No. 2000-15
(Mercury Jet Drives No. 2000-03)

Official Recall Notification Federal Boat Safety Act Voltage Regulator – 240 HP Jet Drive

240 HP M² Jet Drives – 2000 and 2001 Model year product

a - Voltage Regulators

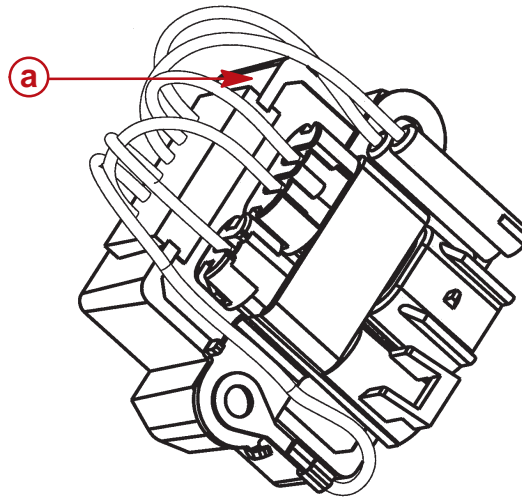
Voltage regulators in use on products identified above are at risk for experiencing an electrical short. A short, if it occurs, could be an ignition source for any flammable material in close proximity to the voltage regulator. Because of this potential for fire or explosion, Mercury Marine will replace the voltage regulators on the affected 240HP M² Jet Drives as listed above.

a - Location of Green Dot

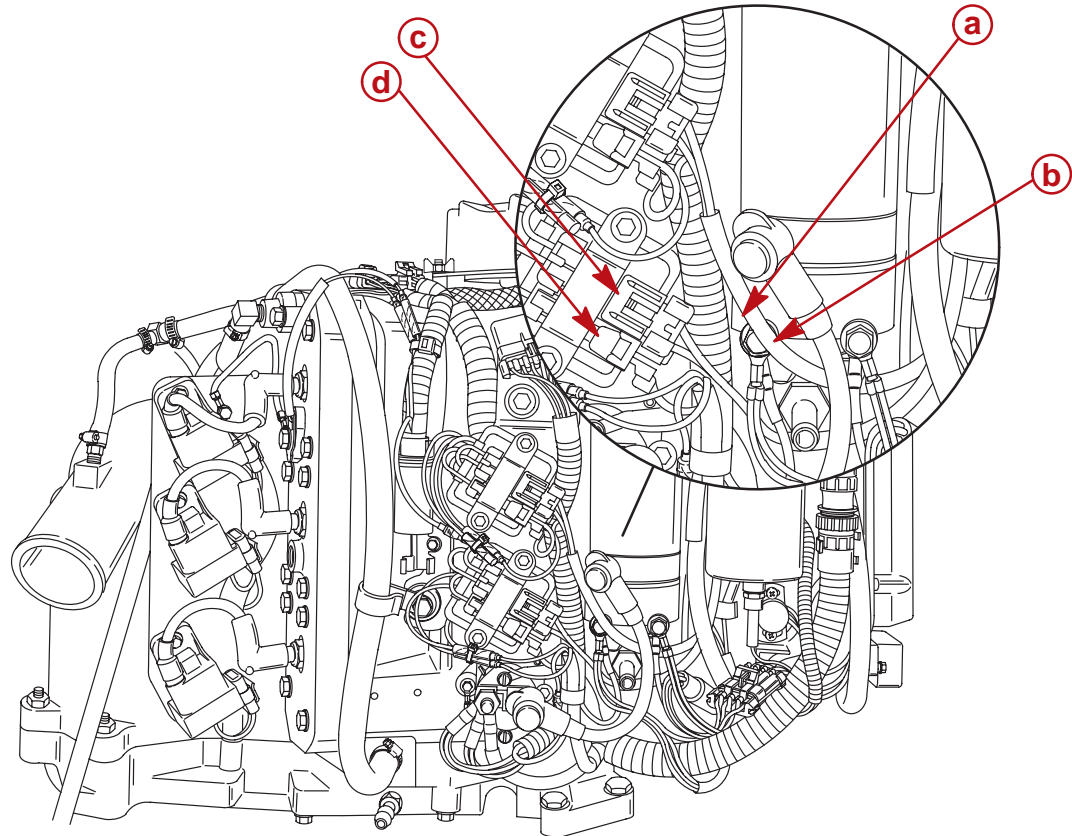
Visually inspect the voltage regulators in **your** parts inventory. A **GREEN** paint dot is located next to the grommet where the wires exit the regulator. There is a part number (883072-1) printed on the side of the regulator. If the regulators do not have these identification marks, **DO NOT USE THEM FOR REPLACEMENTS. REMOVE THEM FROM YOUR INVENTORY, AND USE ONLY THOSE REGULATORS SPECIFIED IN THIS BULLETIN. Complete a warranty claim referencing this bulletin and return those regulators to Mercury Marine.**
